Access Compliance Report

Public Rights-of-Way

(Curb Ramps)

Intersection ID: N/A	Main Street: PATIMBY_RD	Cross Street: MCALPINE_PARK_DR	Location: SE
ADA ID: 3E618750D8F0	Ramp Type: PerpDiag	Initial Pass/Fail: Fail	Overall Compliance: No
Codes/Mitigation Info/Possible Solution		Field Measurements/Component Compliance

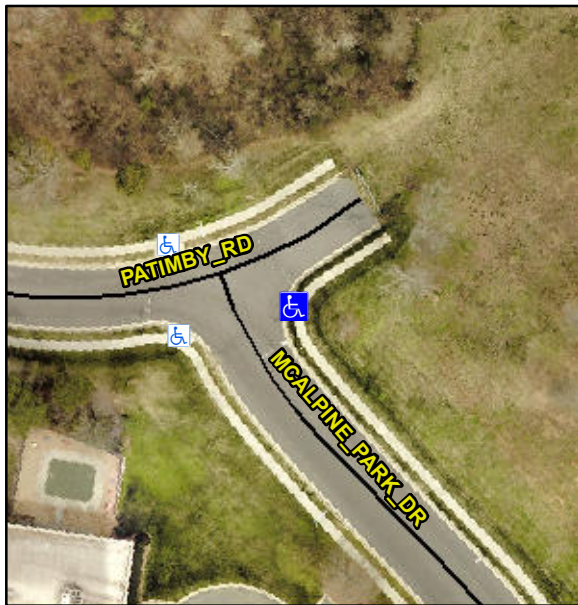
Not Found, R304.2.2, R304.5.3

Compliance	Description	Data	Compliance	Description	Data
N/A	Ramp Length (in)	48.0	No	Ramp Slope (%)	8.6
Yes	Ramp Width (in)	48.0	No	Ramp XSlope (%)	4.6
N/A	Flare Type LT	N/A	N/A	Flare Type RT	N/A
N/A	Flare Slope LT (%)	N/A	N/A	Flare Slope RT (%)	N/A
N/A	Flare Traversable LT?	N/A	N/A	Flare Traversable RT?	N/A
N/A	Landing Length (in)	N/A	N/A	DWS Provided?	N/A
N/A	Landing Width (in)	N/A	N/A	DWS Contrast?	N/A
N/A	Landing Slope (%)	N/A	N/A	DWS Length (in)	N/A
N/A	Landing X Slope (%)	N/A	N/A	DWS Full Width?	N/A
N/A	Landing Curb? (Y/N)	N/A	N/A	DWS Offset (in)	N/A
N/A	Shared Landing?	N/A			
N/A	Gutter Ponding?	N/A	N/A	Gutter Slope (%)	N/A
N/A	Gutter Lip Ht (in)	N/A	N/A	Gutter X Slope (%)	N/A
N/A	Painted X Walk1?	No	N/A	Painted X Walk2?	No
	X Walk 1 Direction	To N		X Walk 2 Direction	To W
N/A	X Walk 1 Width (in)	N/A	N/A	X Walk 2 Width (in)	N/A
	X Walk 1 Slope (%)	0.3		X Walk 2 Slope (%)	1.9
	X Walk 1 X Slope (%)	4.0		X Walk 2 X Slope (%)	1.6

Remove & Replace Curb Ramp With Two New Directional Ramps or Equivalent.
